76 Rutledge Street, Eastwood - LDA2022/0038

Demolition, new two storey dual occupancy (attached) and Torrens title subdivision

City of Ryde Local Planning Panel Report

Figure 9 – Location of existing trees

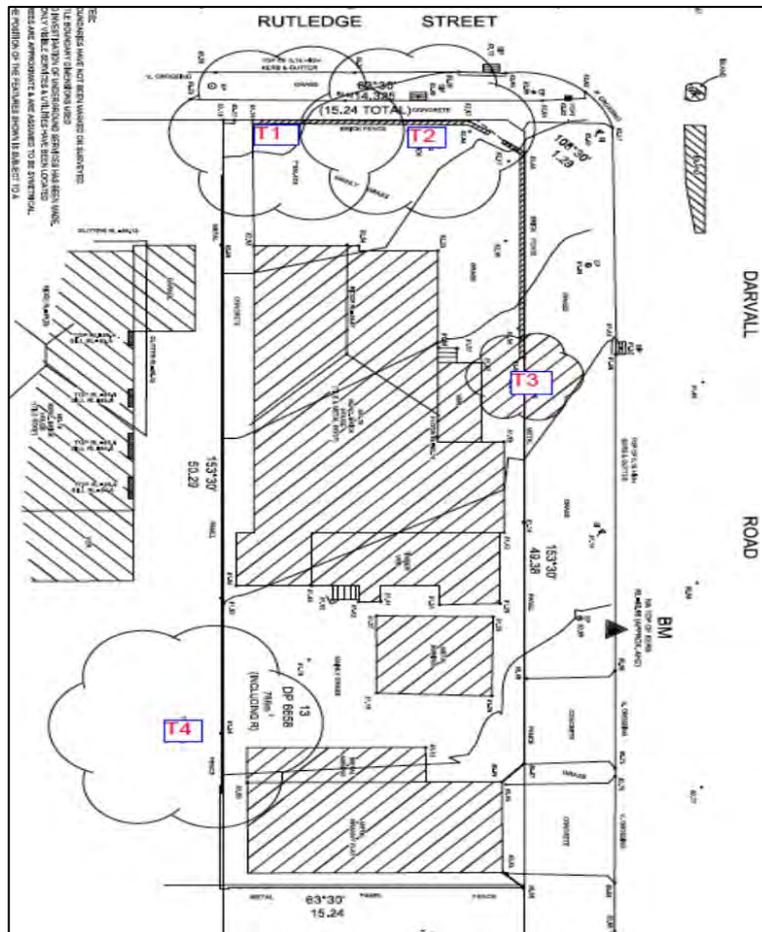
The removal of Tree 2 is not supported as the proposal does not impact on the tree. **Condition 54** is recommended requiring Tree 2 to be retained and protected.

Figure 16 – Primary road frontage notated on survey plan

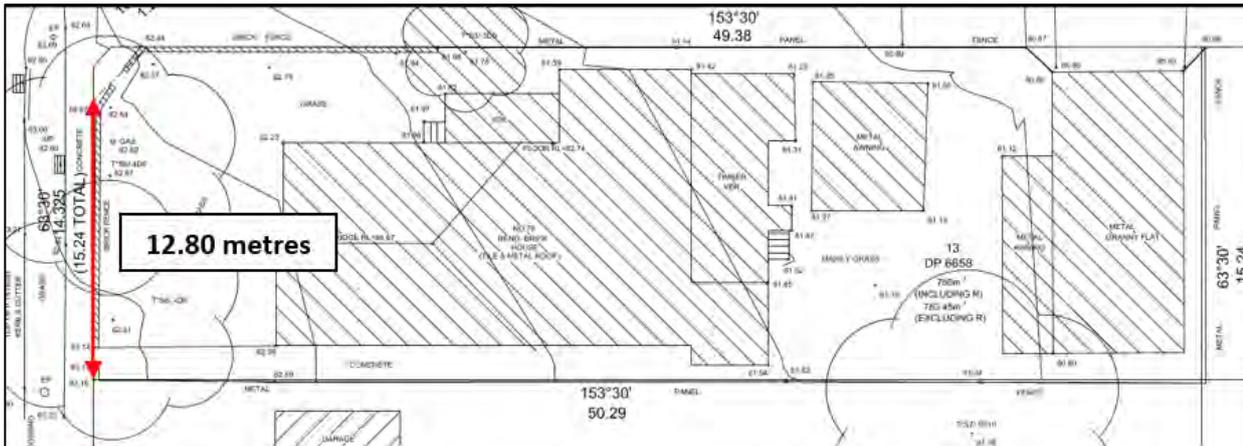
The site has a primary road frontage of 12.80 metres and does not comply with the development standard and represents a 14.67% or 2.20 metres contravention of the development standard.

Figure 17 – Width of lot measured at front setback

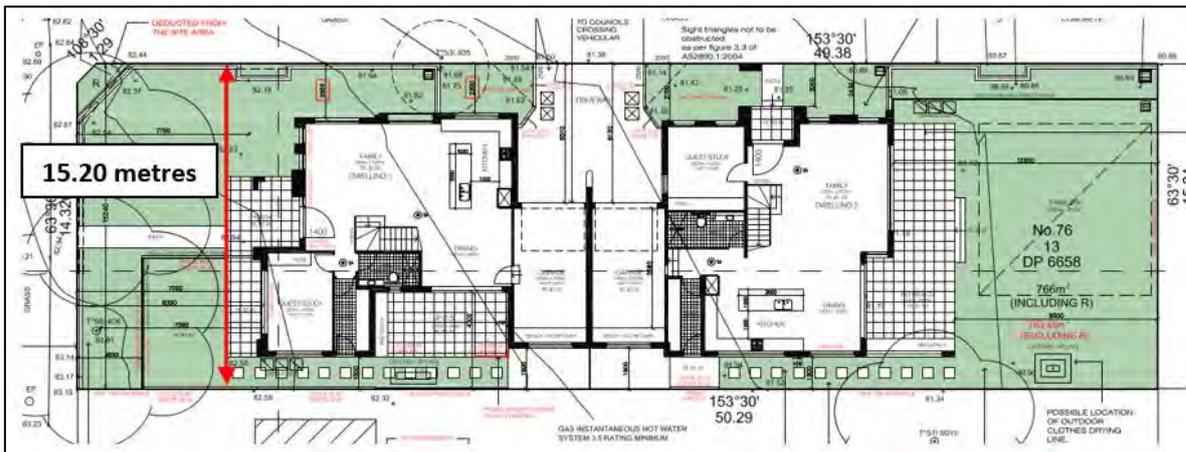
- Clause 4.1B(2) permits dual occupancy development (attached) if the area of the site is equal to or greater than 580sqm, and also has a primary road frontage of equal to or greater than 15m. This is understood to be most relevant on standard rectangular residential allotments, where there is only one road frontage and therefore the frontage needs to extend for an appropriate distance to allow two dwellings on the allotment. The subject site is a corner allotment. The corner allotment allows a design with a suitable outcome despite the 2.20 metre primary road frontage deficiency.
- Measured at the required front setback, the width of the allotment is approximately 15.20 metres which complies with the LEP requirement.

Figure 18 – Rear setback notated on ground floor plan

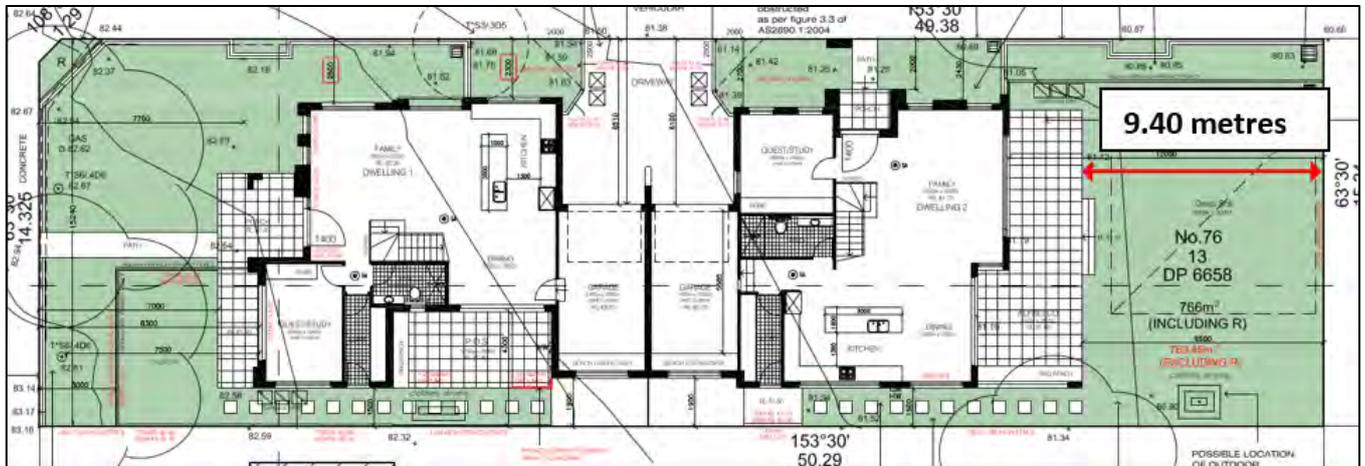
Control 2.9.3(a) states the rear of the dwelling is to be set back from the rear boundary a minimum distance of 25% of the length of the site or 8 m, whichever is the greater. The rear setback required is 12.57 metres, being 25% of the site length. The rear setback measured to the alfresco associated with Dwelling 2 is 9.40 metres (**Figure 18**) which does not meet the rear setback requirement of 12.57 metres. The proposal is considered acceptable for the following reasons:

The non compliance is considered acceptable.

Figure 19 – Screen planting (circled in red) concealing the privacy screen

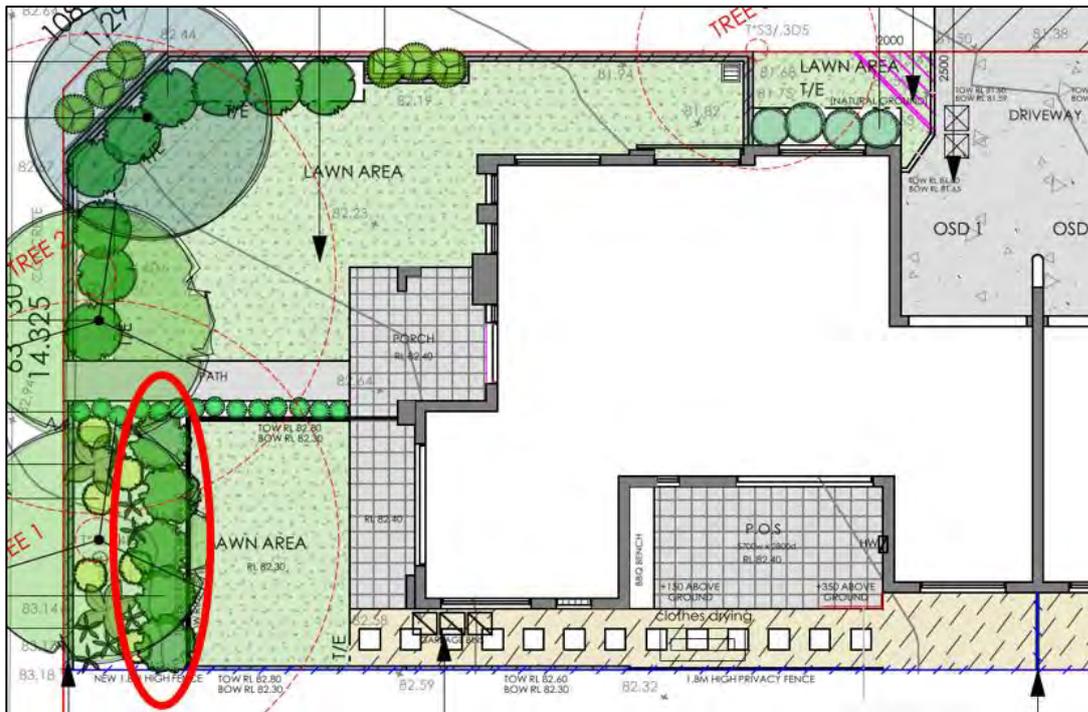
The non compliance is considered acceptable as a north western landscaped private open space area is provided to Dwelling 1. The north western landscaped private open space area receives solar access between 9am and 3pm and provides reasonable solar amenity to Dwelling 1. It is noted the north western landscaped private open space area is located within the front setback. This is considered acceptable as there are no ancillary structures proposed within the landscaped private open space area. The landscape plan shows five (5) *Viburnum Emerald Lustre* (Sweet Viburnum) plants with a mature height of 3 metres are proposed to the north west of the privacy screen surrounding the private open space area and conceal the privacy screen.

Figure 20 – The section of the privacy screen to be extended is shown in blue

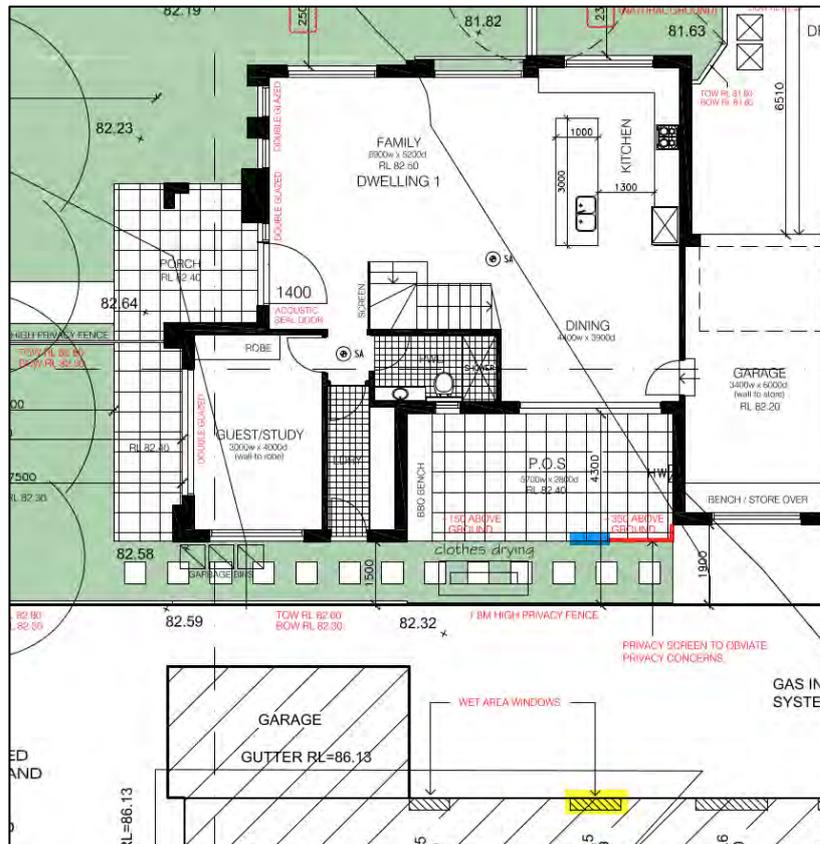
- Window associated with the study/guest room. The window has a sill height of 1.8 metres. The windows sit above a standard sight line and will have no adverse impact on the adjoining property.
- Glass sliding door associated with the dining room. The glass sliding door is elevated and aligns with a window (highlighted in yellow in **Figure 20**) within the neighbouring property at No. 78 Rutledge Street. **Condition 1(a)** is recommended requiring the Dwelling 1 alfresco privacy screen to be extended for a length of 1 metre.

Figure 22 – Location of electricity poles highlighted in yellow

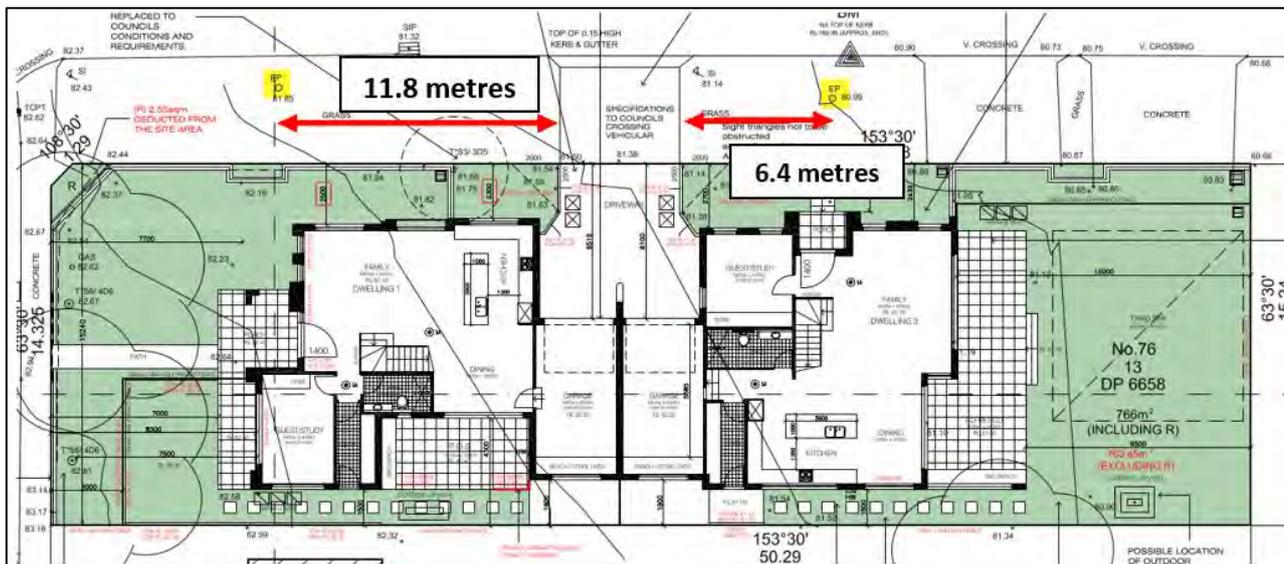
Comment: There are four (4) existing electricity poles around the site. Concern is raised with the location of the driveway and proposed building from the electricity poles.

Assessing Officer comment's: There are two (2) existing electricity poles on the Darvall Road frontage. The driveway is approximately 11.8 metres from one electricity pole and 6.4 metres from the other electricity pole. The distance between the driveway and electricity poles is considered acceptable. The proposed building is within the site boundary and will not impact on the electricity poles. Control 2.9.1(b) requires on corner sites, the setback along the secondary street (the street to which the house has its secondary frontage) is to be a minimum of 2m. The proposal is setback 2.0 metres from the secondary street and complies with Control 2.9.1(b).

Figure 24 – Existing shadow diagram showing existing dwelling does not overshadow the neighbouring dwelling between 12pm and 3pm

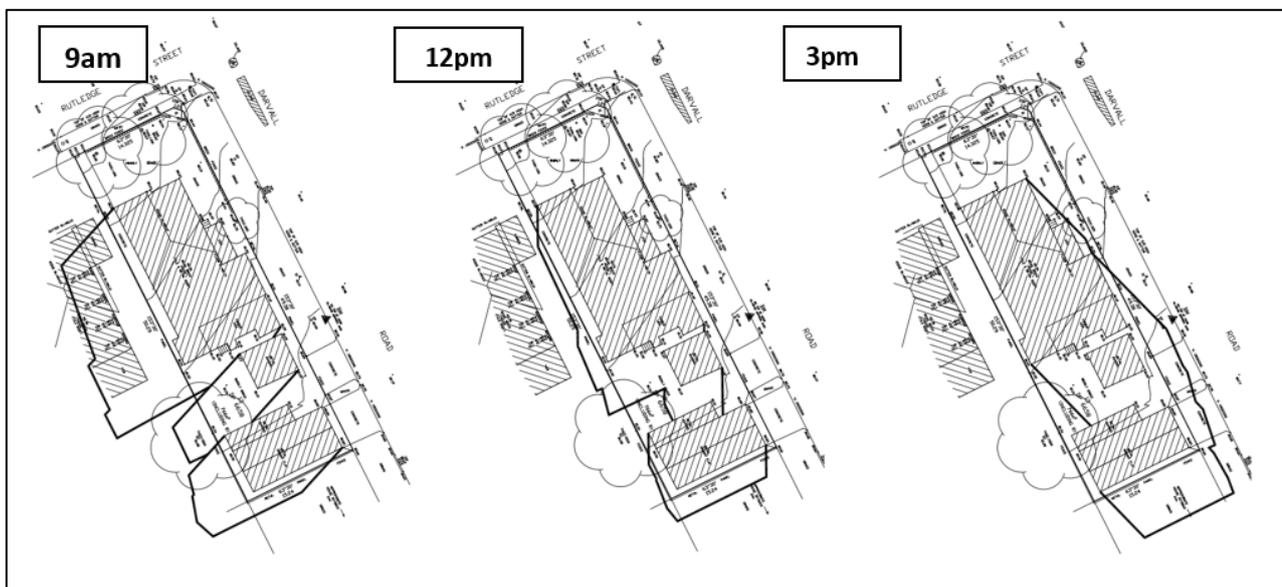
Comment: Concern is raised sunlight is going to be lost to the east and south side of 78 Rutledge Street.

Assessing Officer comment's: The existing shadow diagrams show the existing dwelling at No. 76 Rutledge Street overshadows the north eastern elevation of No. 78 Rutledge Street at 9am and does not overshadow the neighbouring dwelling between 12pm and 3pm.
